U.S. Department of the Interior
BUREAU OF LAND MANAGEMENT

| Well Name: POKER LAKE UNIT | Well Location: T25S / R31E / SEC 4 / SESW / | County or Parish/State: EDDY / NM |

Sundry ID: 2649075

Type of Action: Temporary Abandonment

Poker Lake Unit 303H - Current and Proposed WBD's

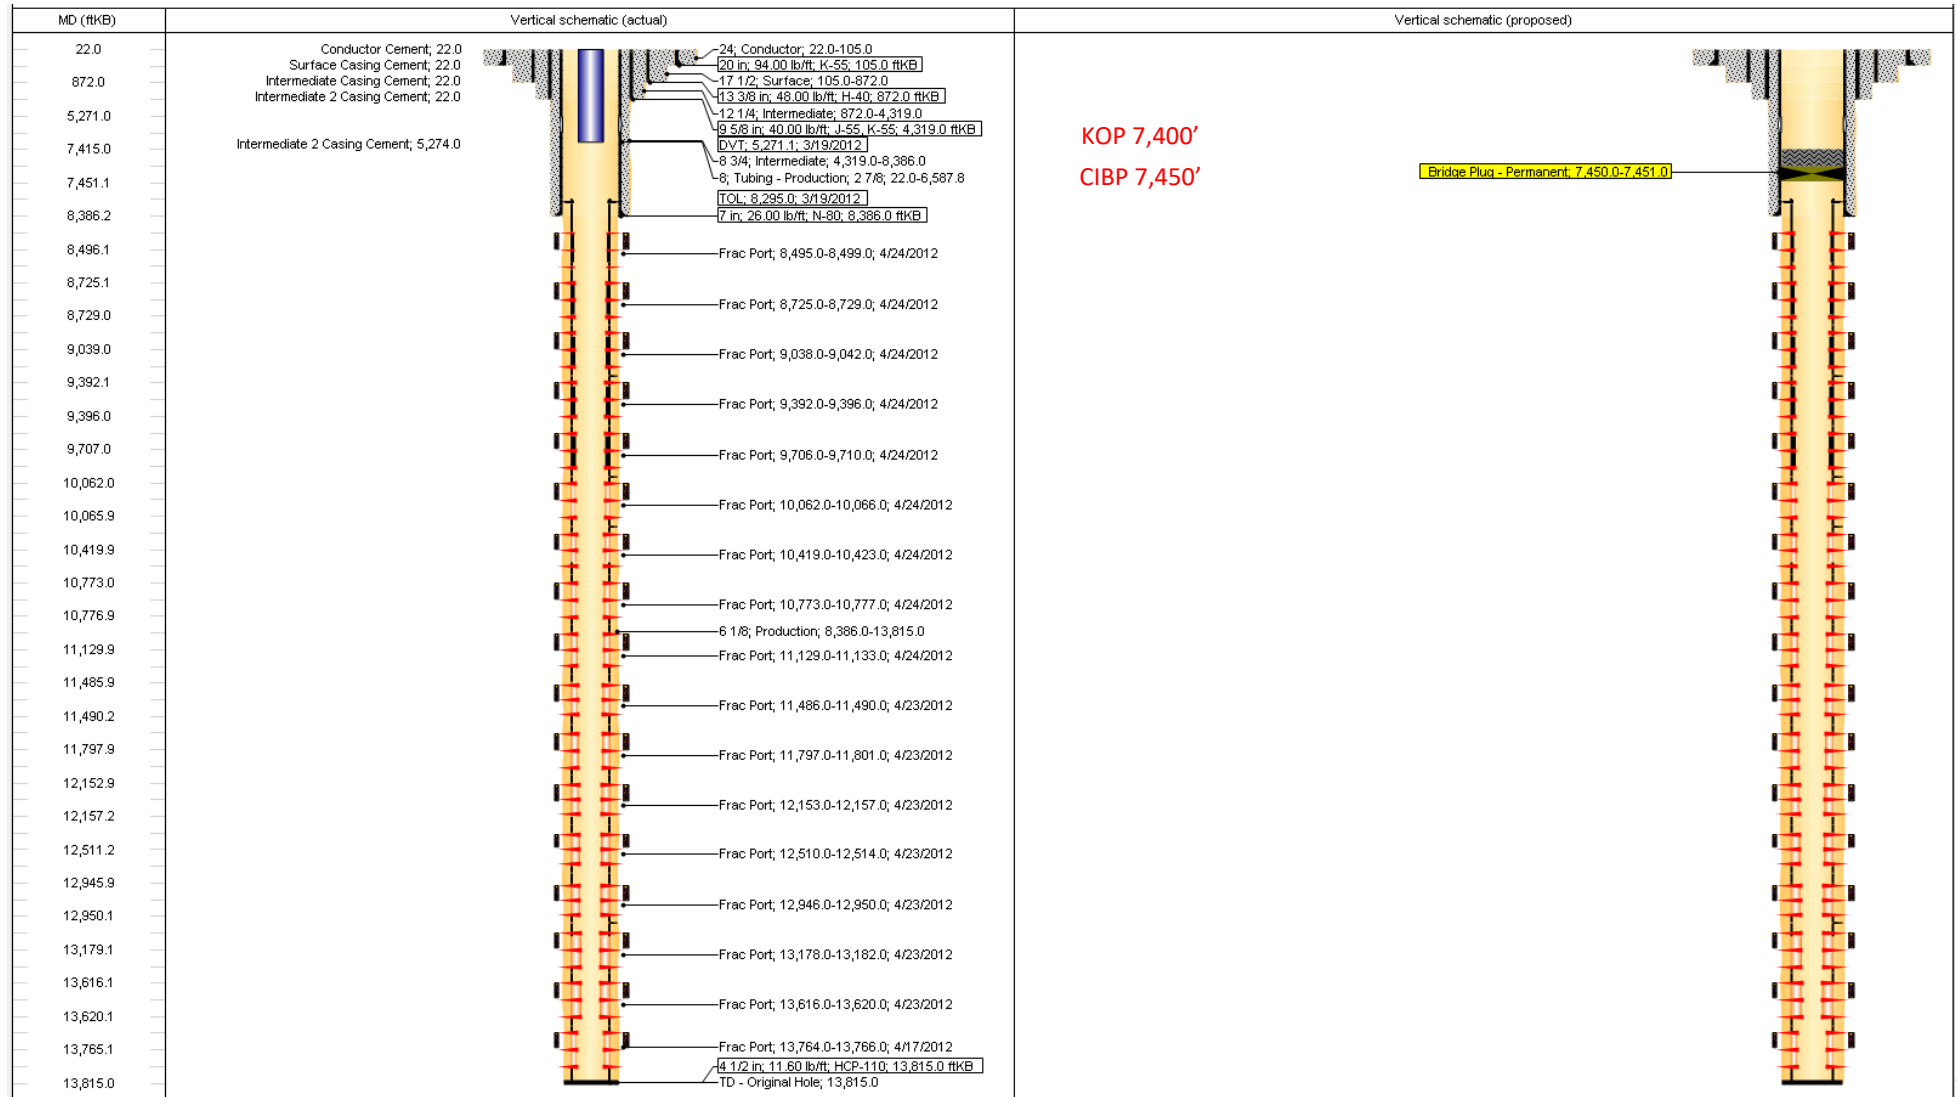
2. A bridge plug (CIBP) must be installed 50 to 100 feet above any open perforations or open hole. The CIBP must be capped with either a minimum of 25 sacks of cement if placed with tubing or 35 feet of cement if placed with a bailer. The top of the cement must be verified by tagging.

3. The wellbore must be filled with corrosion inhibited fluid and pressure tested to 500 psi. The casing shall be capable of holding this pressure for at least 30 minutes. If the well does not pass the casing integrity test, then the operator shall, within 30 days, submit a procedure to either repair the casing or to plug and abandon the well.

5. All downhole production/injection equipment (tubing, rods, etc.) shall be removed from the casing if it is not isolated by a packer.
6. A bradenhead test must be conducted. If the test indicates a problem, a remedial plan and time frame for remediation shall be submitted within ninety (90) days of the test.

7. Submit a subsequent Sundry Notice (Form 3160-5) with the following information:
 - a. A well bore diagram with all perforations, CIBP's, and tops of cement on CIBP's.
